City of Surrey  
**PLANNING & DEVELOPMENT REPORT**

File: 7910-0319-00

Planning Report Date: May 30, 2011

in order to permit development of a retail store (Loblaw Superstore) in Grandview Corners and to vary the east side yard setback and permit additional fascia signage.

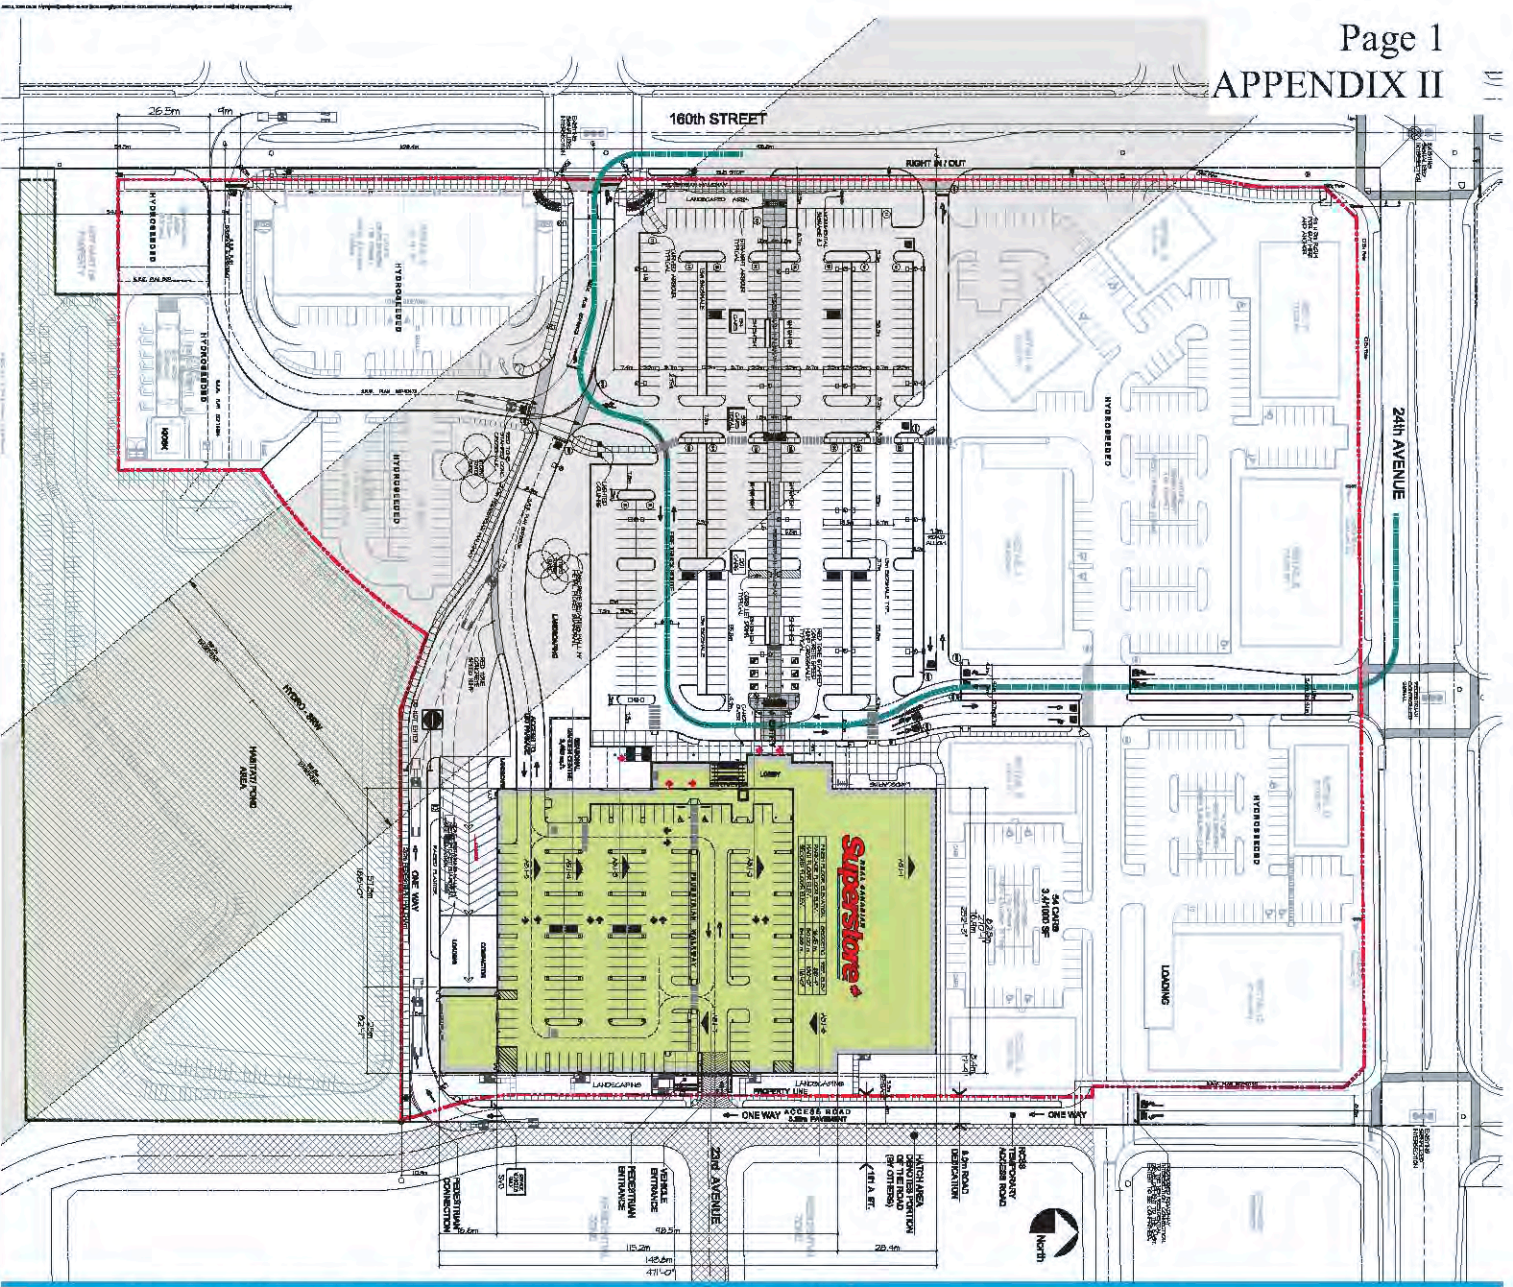
- To reduce the minimum side yard setback (east) of the CD Zone (By-law No. 15611) from 13.5 metres (45 ft.) to 2.0 metres (6.6 ft.) for entry features.

- The applicant has agreed to dedicate 8.0 metres (26 ft.) for 161A Street, a road that has been envisioned through the planning process for the Sunnyside Heights NCP. To allow the building siting to remain the same, the setback from the property line is proposed to be 5.5 metres (18 ft.).

- The east building face will be set back 6.1 metres (20 ft.) from the property line. However, there are some entry features including a protruding wall that are closer to the property line. Therefore, the setback is proposed to be varied to 2.0 metres (6.6 ft.). A site plan will be attached to the Development Variance Permit which will specify the siting of buildings and structures (Appendix V).

EAST ELEVATION

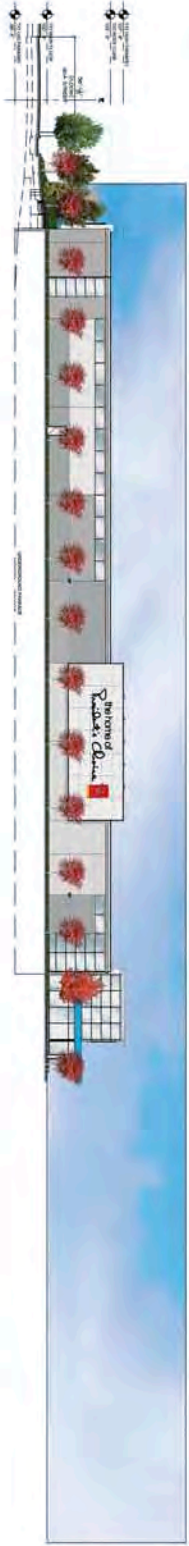
- Provide a better east side "front door" for cars and pedestrians with a scale appropriate to the residential across the street.  
Reworked the East Elevation has been design to provide appropriate scale to the eastern residential developments.

- Entry east side – if there is pedestrian entry it should be visually indicated. The pedestrian entry has to be indicated to people so they know they can go that direction.  
Design re-worked to provide pedestrian focus and scale.

- East elevation needs design development; entry needs more definition. Scale needs to be broken down to provide smaller scale addressing residential across the street. Consider a more vigorous architectural entry treatment for the east facade of the building, particularly for pedestrians.  
We have re-designed the entrance feature by scaling down and adding a free standing concrete tower which supports a horizontal painted steel structural beam. This new structure encompasses generous stair and disabled persons ramp accesses to the parkade.

- It's the longest unbroken elevation, pump up the stair, add screening and landscape it and / or break the parapet line; like the differentiation and shadow line on wall.  
As above

- Issue is east facade where it fronts onto the residential – another level of detail can be added to that facade and help it relate to the scale of the future residential across the street.  
As above

- The signage on the east side is huge and it should be more pedestrian oriented on that side. It is way too over scale and too corporate; huge signs should not be facing someone's living room; don't need as much corporate gesture as being shown.  
As above
- More windows on the portal side (west elevation).  
The addition of a glazed screen wall at the Cartveyors and adding landscaped areas along the main sidewalk will reduce the amount of featureless walls.
- More features could be added on the west facade, it is a pretty blank wall, there could be an opportunity to display merchandise.  
As above
- More day lighting into building potentially via skylights.  
Day lighting has been achieved by large sections of clerestory windows around the perimeter of the building and the large glazed entry portal.
